City of Leawood
Planning Commission Agenda
April 23, 2019
Dinner Session – 5:30 p.m. – No Discussion of Items
Leawood City Hall – Main Conference Room
Meeting - 6:00 p.m.
4800 Town Center Drive
Leawood, KS 66211
913.339.6700 x 160

CASE 24-19 – THE MAJESTIC – INDEPENDENT LIVING FACILITY – Request for approval of a Preliminary Plan, Preliminary Plat, and Special Use Permit for an Independent Living Facility, located south of 137th Street and west of Mission Road. **PUBLIC HEARING**

City of Leawood Planning Commission Staff Report

**THE MAJESTIC – INDEPENDANT LIVING FACILITY – REQUEST FOR APPROVAL OF A PRELIMINARY PLAN, PRELIMINARY PLAT AND SPECIAL USE PERMIT FOR AN INDEPENDANT LIVING FACILITY – Located south of 137th Street and west of Mission Road – Case 24-19
PUBLIC HEARING**

New Garage Door

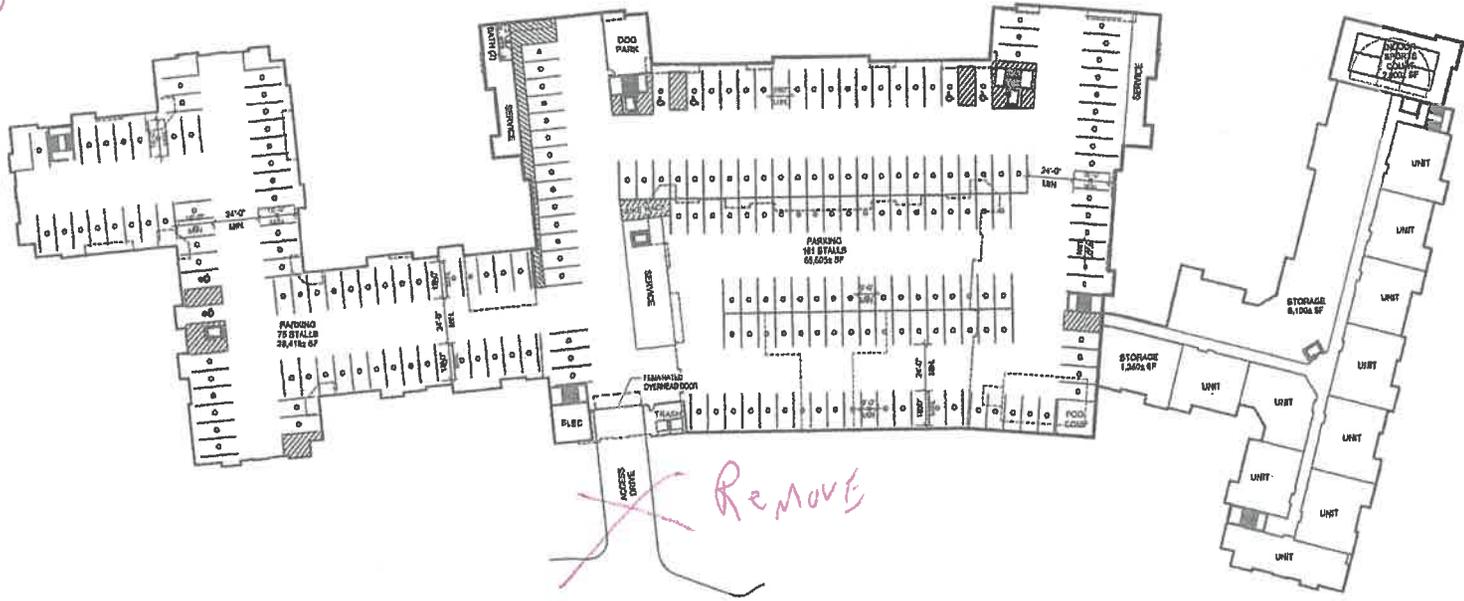
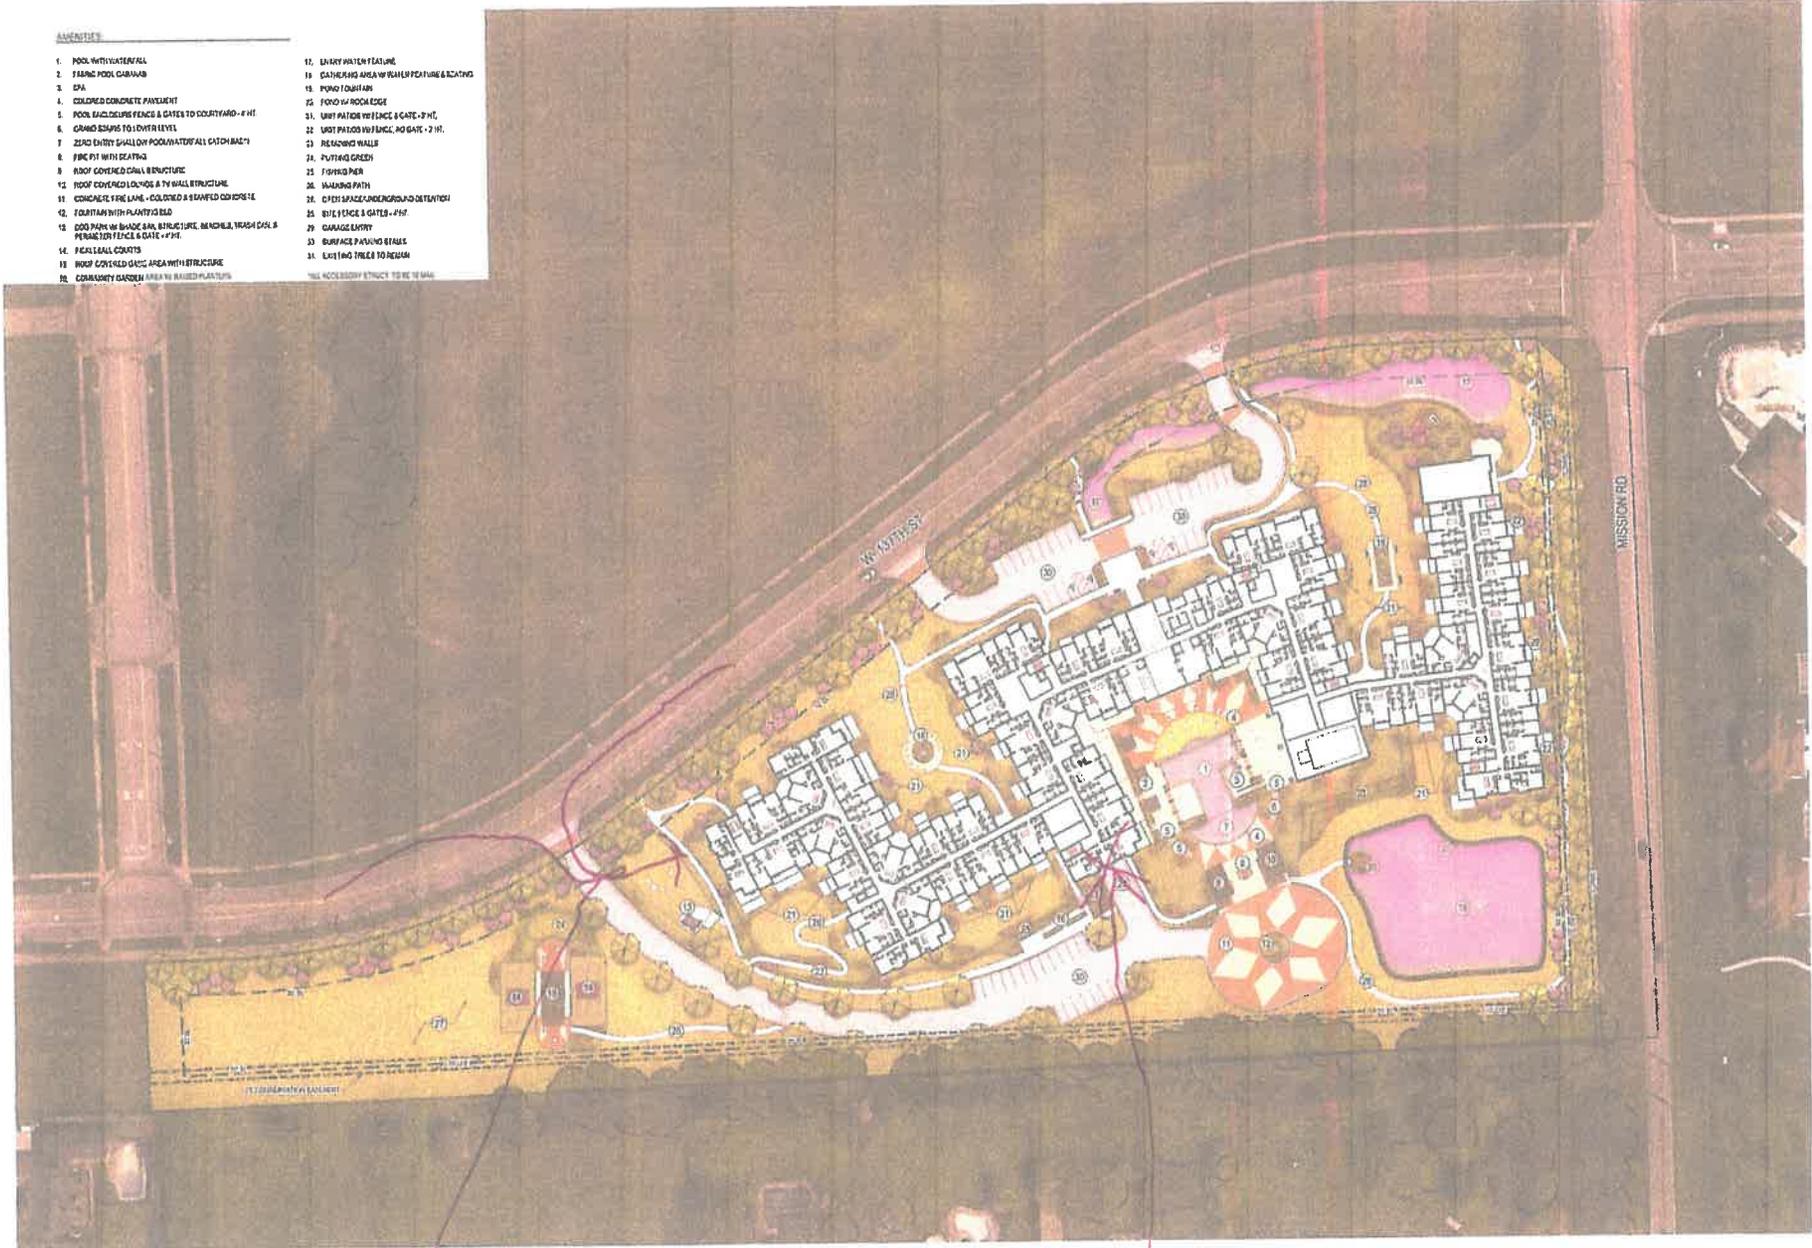
New Better Door

Remove Door
